# CITY OF ALBUQUERQUE

RE: **Lot 24 Block 8 Volcano Cliffs Unit 22 SAD 228**  
**6301 Petirrojo NW**  
**Grading and Drainage Plan**  
**Engineers Stamp Date 12/31/2020 (D10D003E24)**  
**Pad Certification Date 1/30/2021**

Based upon the information provided in your submittal received 2/16/2021, this plan is approved for Building Permit.

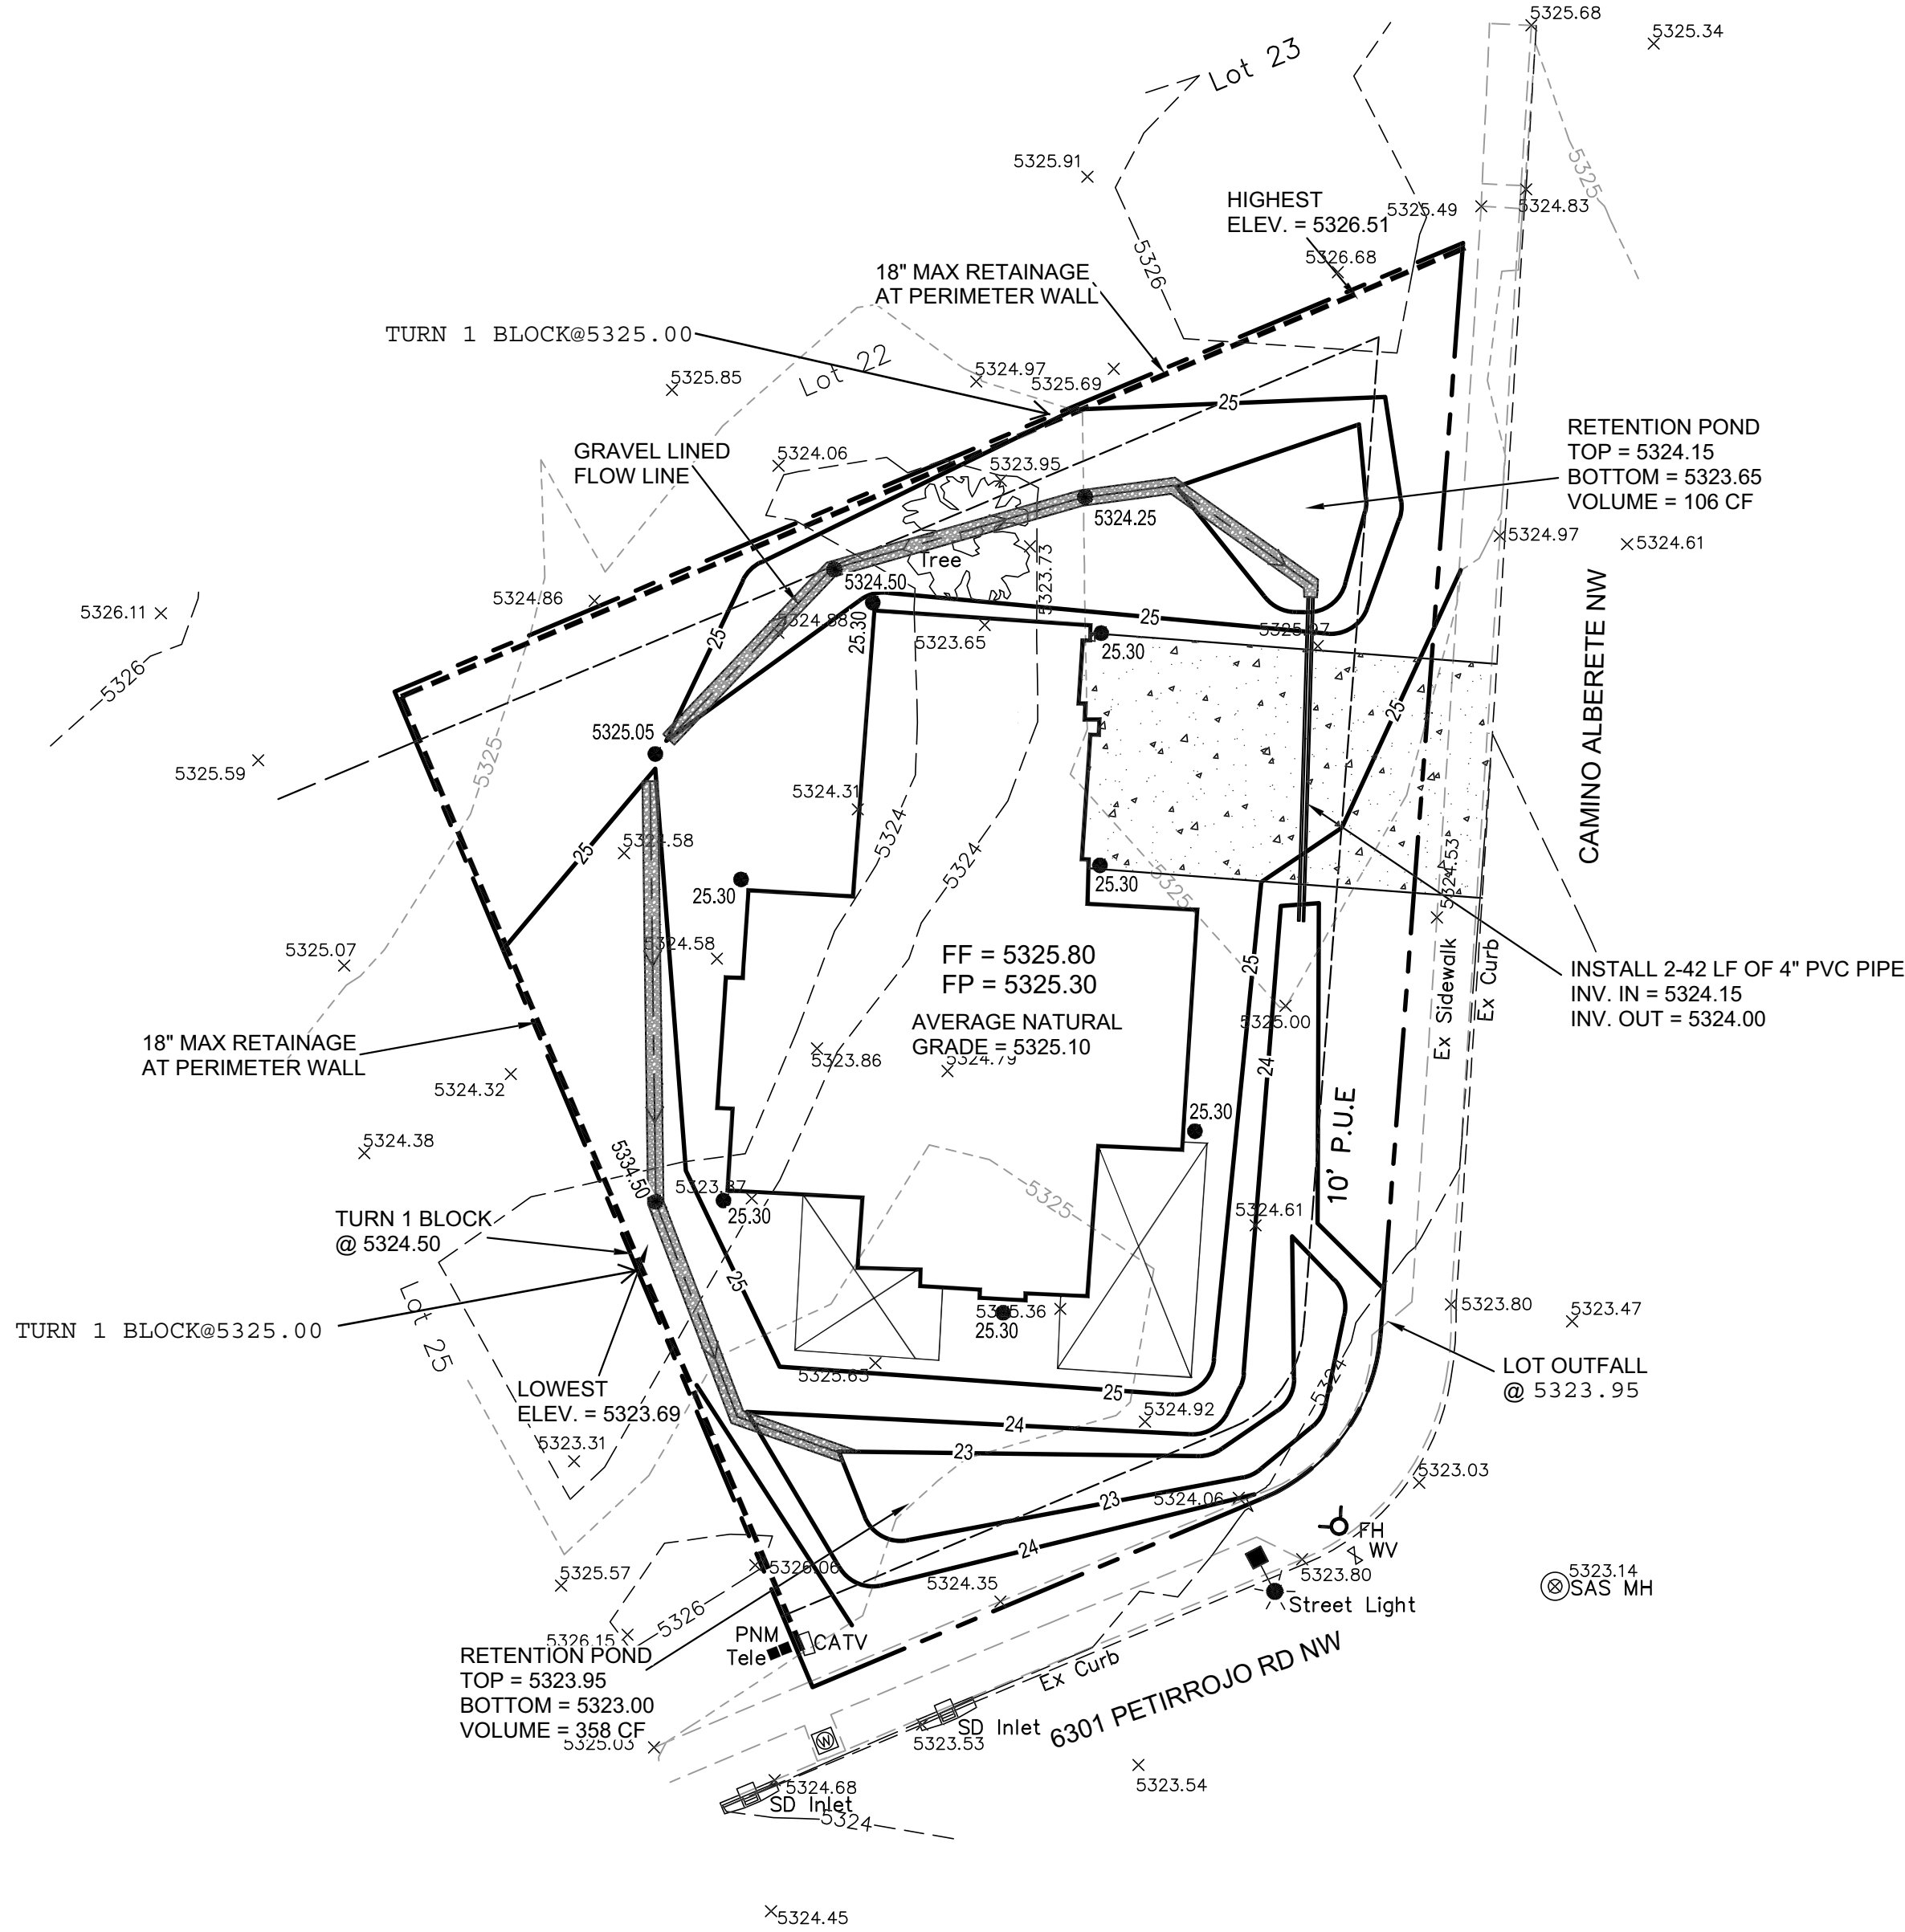
**Reiterate to the Owner/Contractor that a separate permit for a garden/retaining wall must be obtained, with the approved G&D plan and Pad Certification. Also, let the owner/contractor know that if a pool is to be added in the future the G&D plan will need to be modified showing the location of the pool and the land treatment differences.**

Prior to Certificate of Occupancy release, Engineer Certification per the DPM checklist of this plan will be required.
